DEVELOPMENT REVIEW COMMITTEE (DRC) COMMENT REPORT

Project Name: Federal Golf, Inc. / 3800 N. Federal Highway

Case Number: R15014

Request: Site Plan Level II Review: 36,711 sf Retail Development

A-1.0

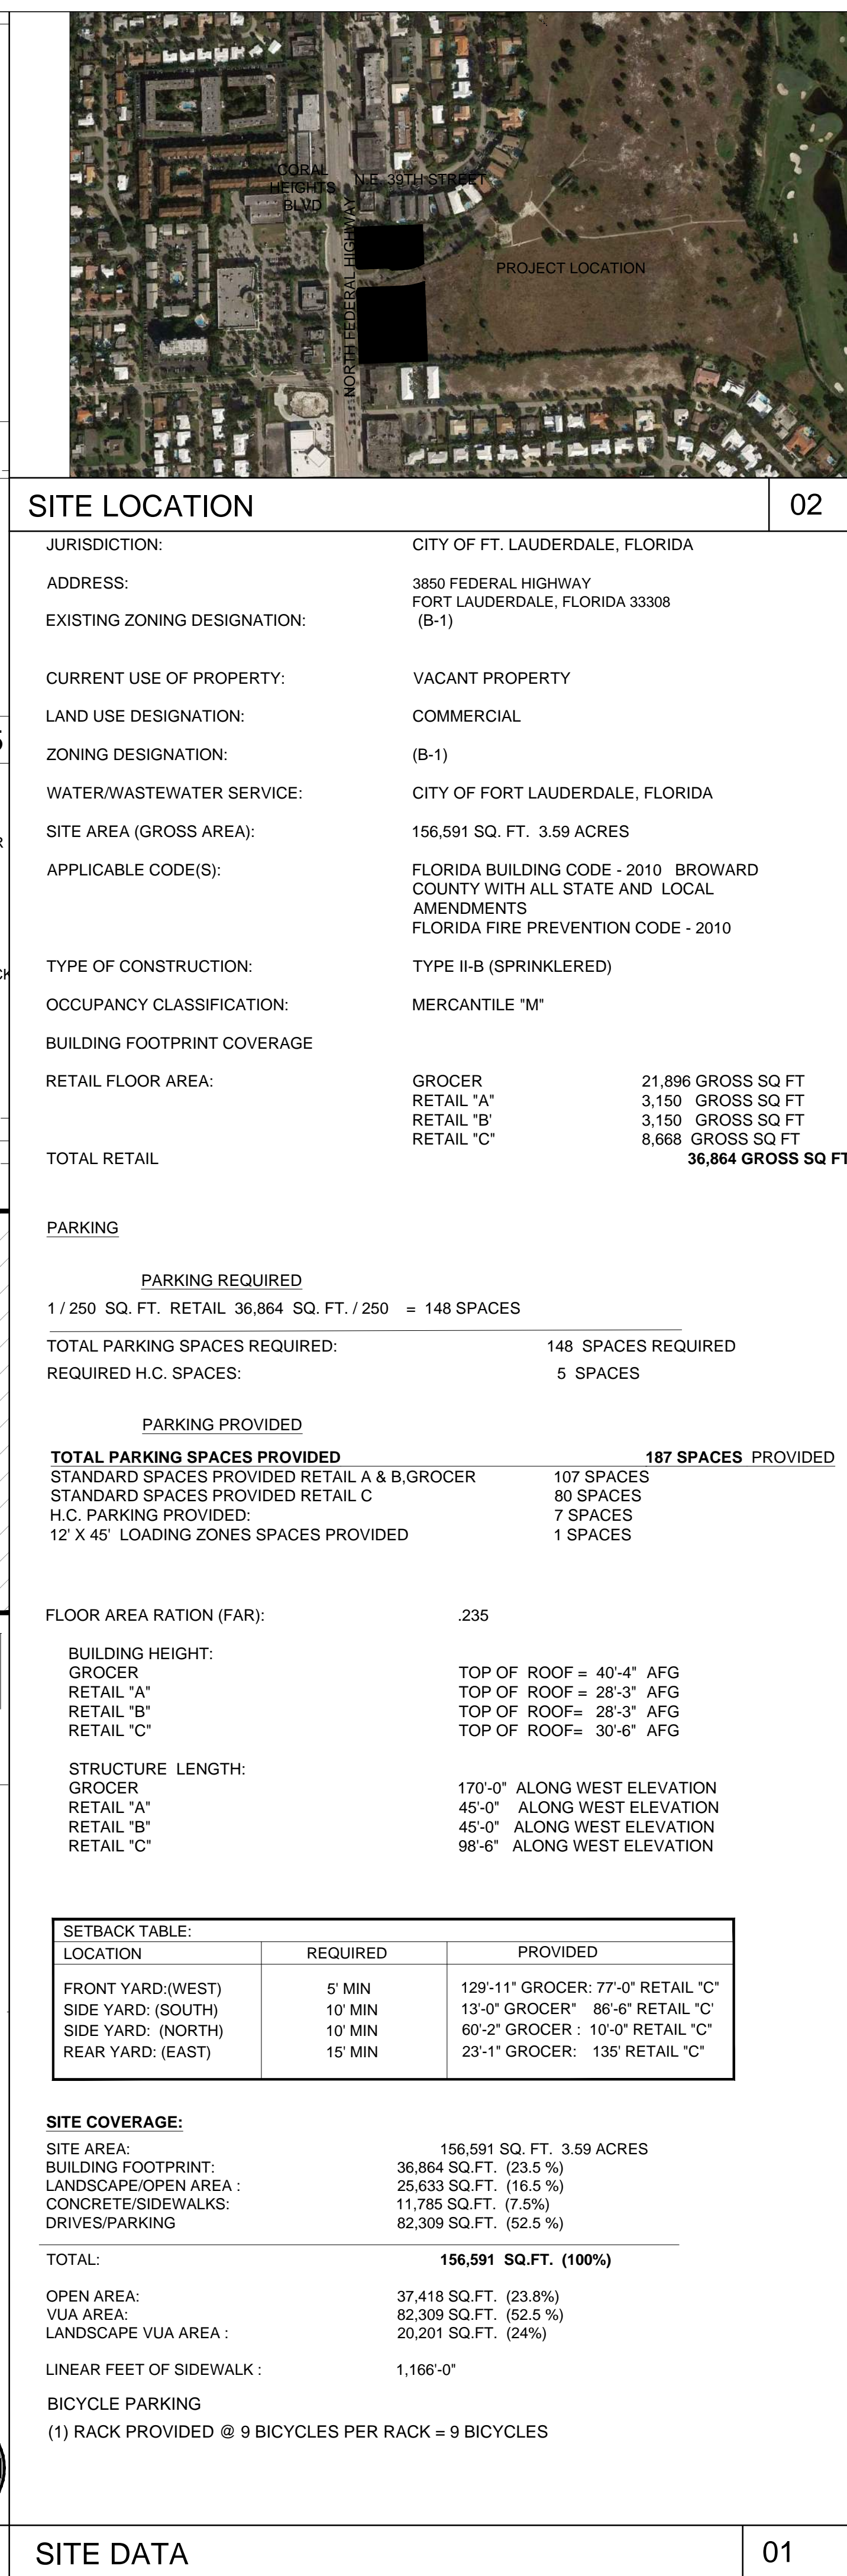
4. Page A-1.0 Ground floor Elevations heights required.

13. Provide details for the proposed 'Landscape Wall(s)' called out on Sheet A-1.0.
14. Inconsistencies noted between Sheet A-1.0 and Sheet PGD-1, such as: extents of new sidewalk on north side of street that splits the proposed Retail/Grocer site; locations of 'Proposed Monument Sign(s)' fronting N. Federal Hwy; disposition of existing 5'-wide sidewalk where it intersects the street that splits the proposed Retail/Grocer Site; and layout of 'Striped Area' located in the SE corner of the proposed development.

A-6.1

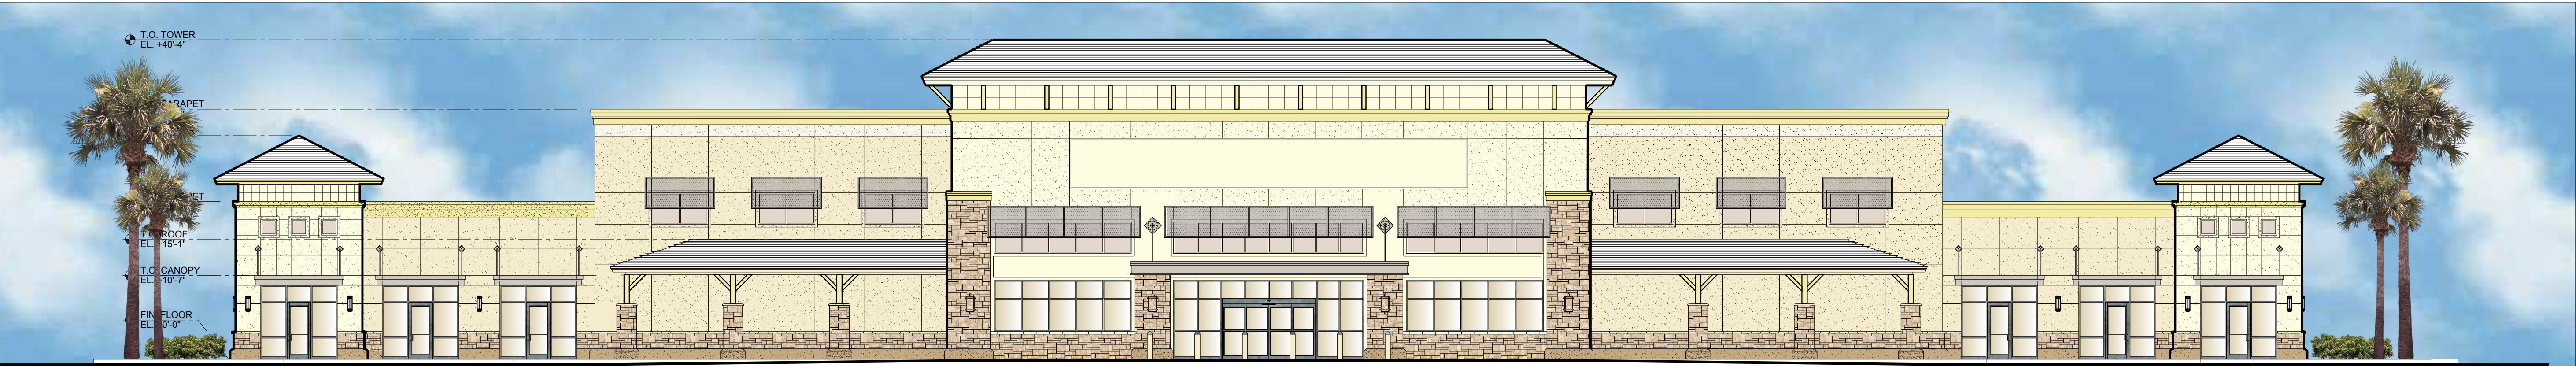
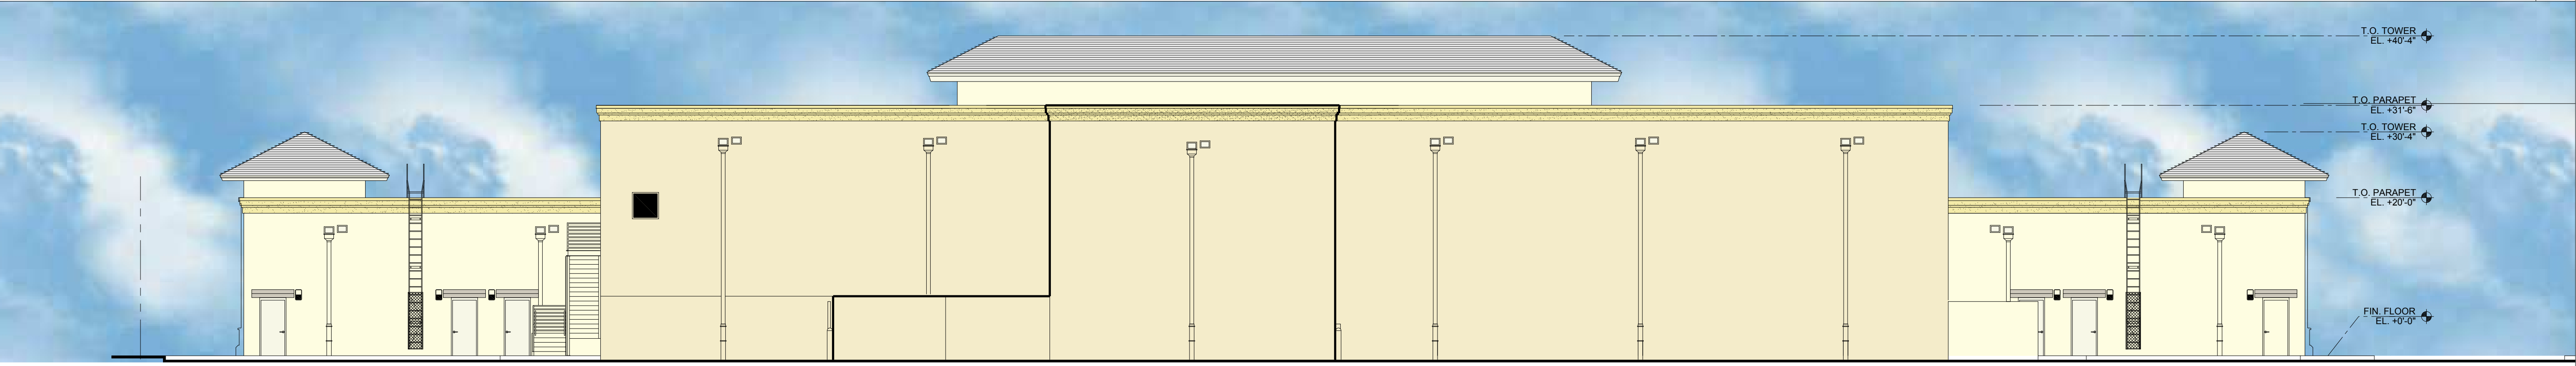
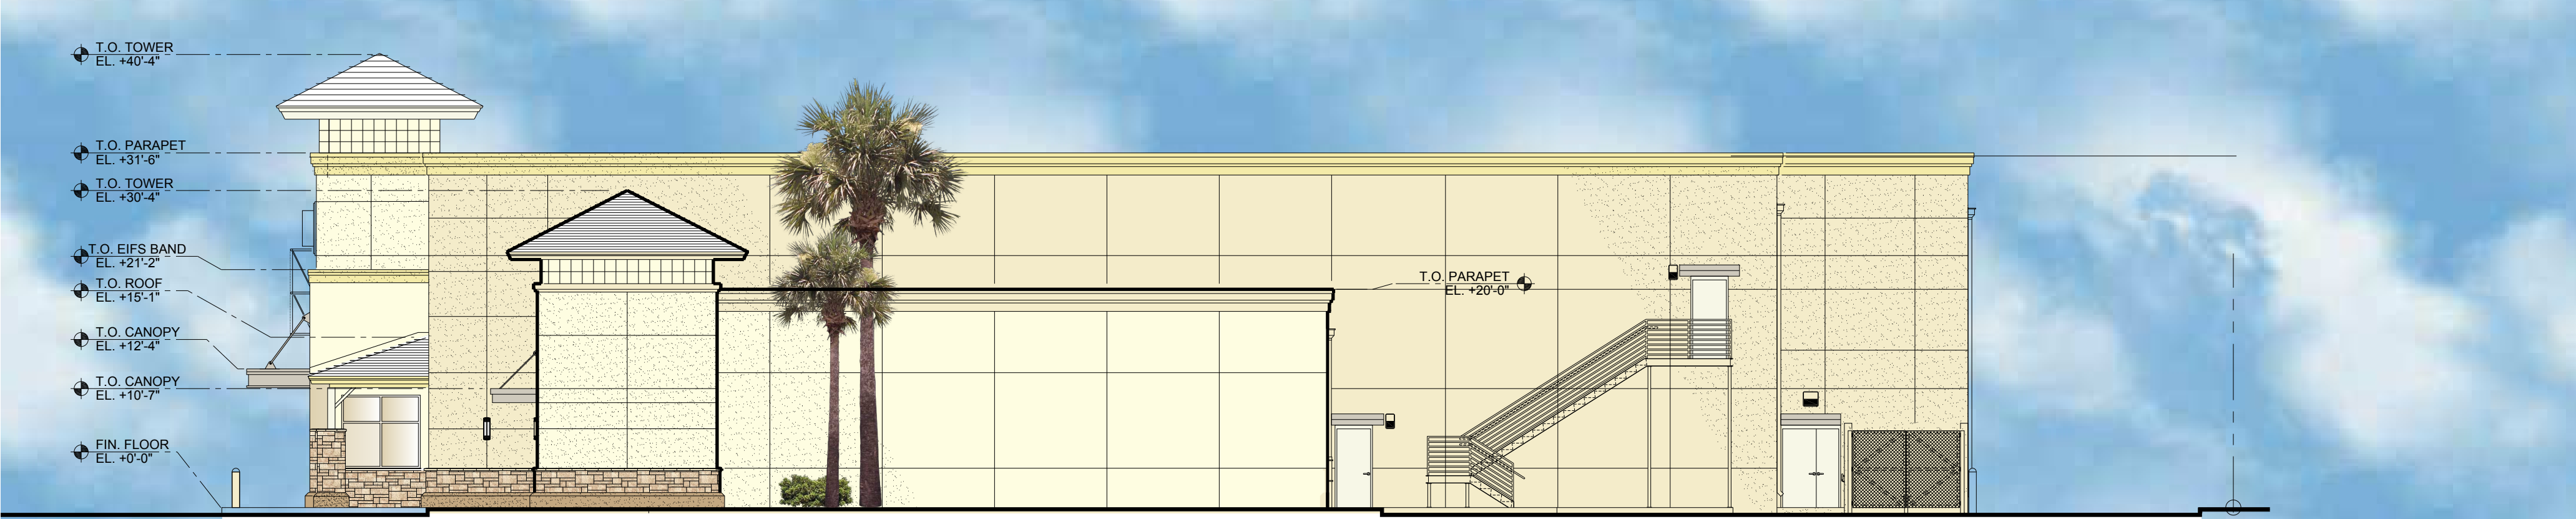
- Stagger tree islands in parking lot to more evenly distribute shade trees.
- 10) Provide the following changes on the elevations:
- Provide articulation on rear walls of proposed buildings, as they will be plainly visible from the park.
